# UNITED STATES PATENT AND TRADEMARK OFFICE

APPLICATION NO.	FILING DATE	FIRST NAMED INVENTOR	ATTORNEY DOCKET NO.	CONFIRMATION NO.
10/801,364	03/16/2004	Qingfa Huang	14687-0001	3158
3490	7590	11/02/2006	EXAMINER	
DOUGLAS T. JOHNSON MILLER & MARTIN 1000 VOLUNTEER BUILDING 832 GEORGIA AVENUE CHATTANOOGA, TN 37402-2289			MORGAN JR, JACK HOSMER	
			ART UNIT	PAPER NUMBER
			3782	
DATE MAILED: 11/02/2006

## Office Action Summary

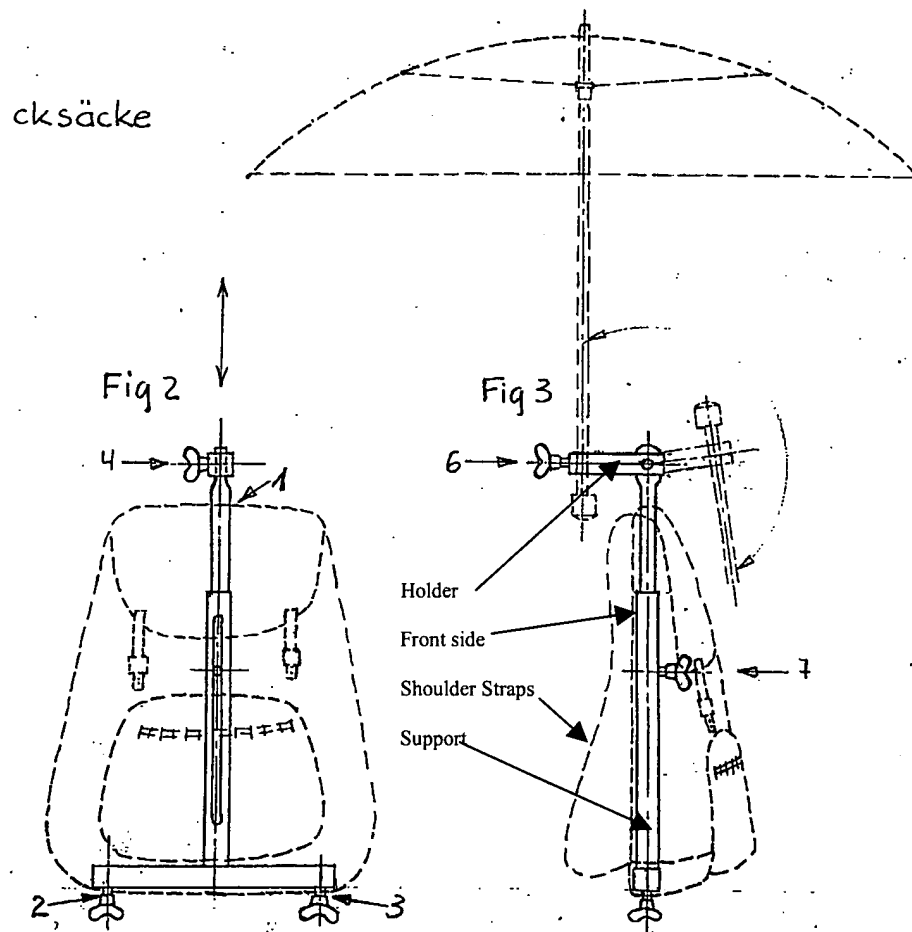
5. Claims 1-6, 8 and 10-12 are rejected under 35 U.S.C. 102(b) as being anticipated by Schmid (DE 29712815). Schmid discloses a backpack (see fig 3, also next page) with a front side and shoulder straps, also having an umbrella support having a top with a holder and an umbrella releasably connected to the holder, where the holder is tilted towards the front side of the backpack at an angle.

In regards to claims 2 and 10, the umbrella support is a round bar, thus having a curved front surface that conforms to the shape of a back. The front of the backpack is made of canvas, so it naturally takes the form of the back it is resting on.

In regards to claim 3, the angle of the holder is not set to a certain degree, thus being able to be in a range of 5 to 20 degrees.

In regards to claims 4 and 8, the umbrella handle and holder are connected by screwing (6).

In regards to claim 5, the umbrella holder is parallel to the back of a user.

In regards to claim 6, the umbrella support is installed in a slot within the backpack.

In regards to claims 11 and 12 the umbrella support is connectedly secured to the backpack by screws (2 and 3)
